Service Bulletin

File in Section: 06 - Engine
Bulletin No.: 13-06-01-003E
Date: April, 2014

Subject: Excessive Oil Consumption – Perform Oil Consumption Test and/or Install Piston and Piston Ring Kit

Models: 2010-2013 Buick LaCrosse
2011-2013 Buick Regal
2012-2013 Buick Verano
2010-2013 Chevrolet Equinox
2012-2013 Chevrolet Captiva
2012-2013 Chevrolet Orlando (Canada Only)
2010-2013 GMC Terrain
Equipped with 2.4L Engine (RPOs LAF, LEA)

Acceptable Cylinder that Does Not Appear Uniform (Zebra Stripes)

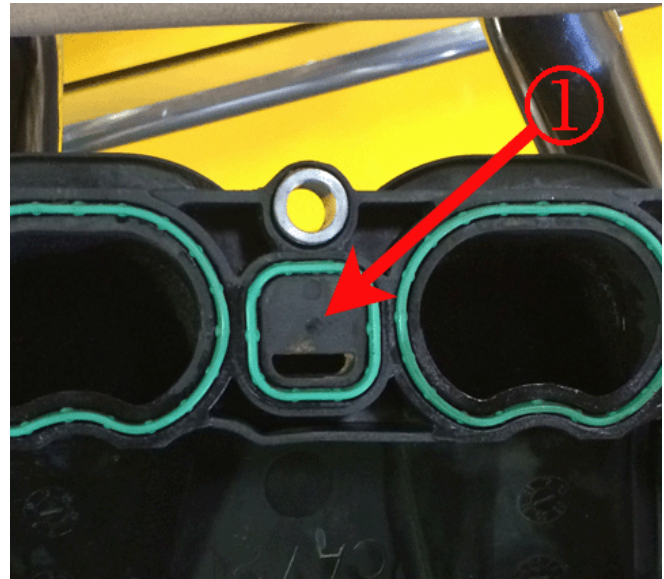
The repair is to replace the pistons and rings. In some cases the bore surface may not have a uniform look to the finish (zebra stripes) as shown below. As a result, some technicians may question whether the engine should be repaired or replaced. After careful evaluation, GM Powertrain has determined that the new pistons and rings will perform correctly in bores that have this appearance so engine replacement should not be necessary. The cylinder bores do not need any machine or honing work performed on them. Refer to the picture below for acceptable surface finishes.

(1) PCV orifice in the intake manifold

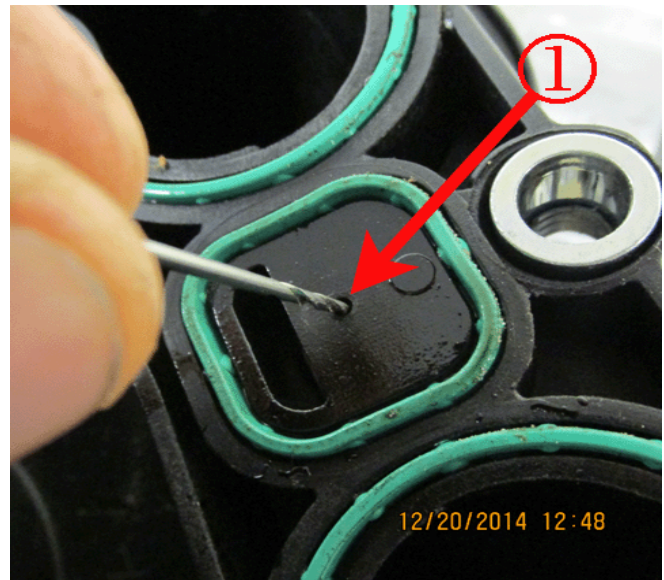
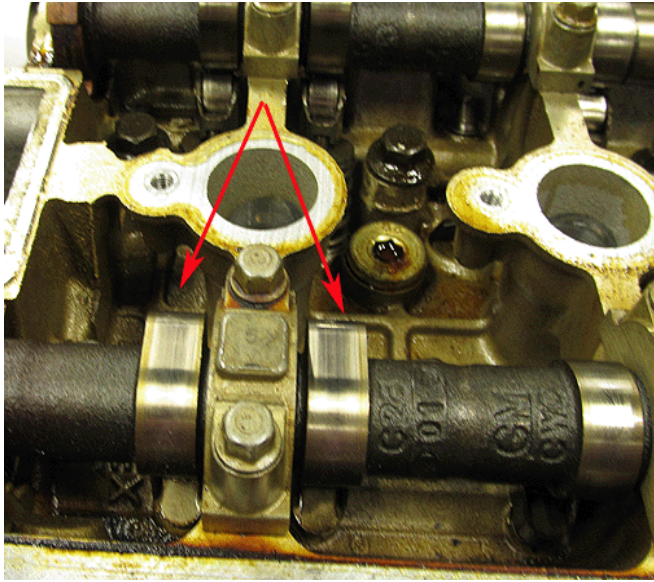
The oil consumption may have clogged/ reduced PCV flow. The PCV system should be serviced.

Clean any ice/sludge/water/carbon out of the PCV pipes/hoses, the PCV nipple on the cam cover, the PCV orifice between the #2 and #3 intake runners (use a 1/16 inch drill bit as illustrated below).

3409678

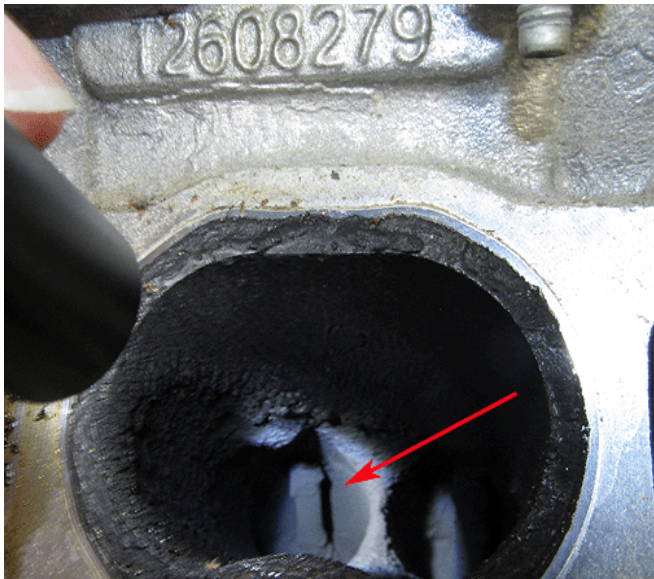
- Camshafts and roller follower will have wear markings. This is normal and do not need to be replaced (refer to picture above).
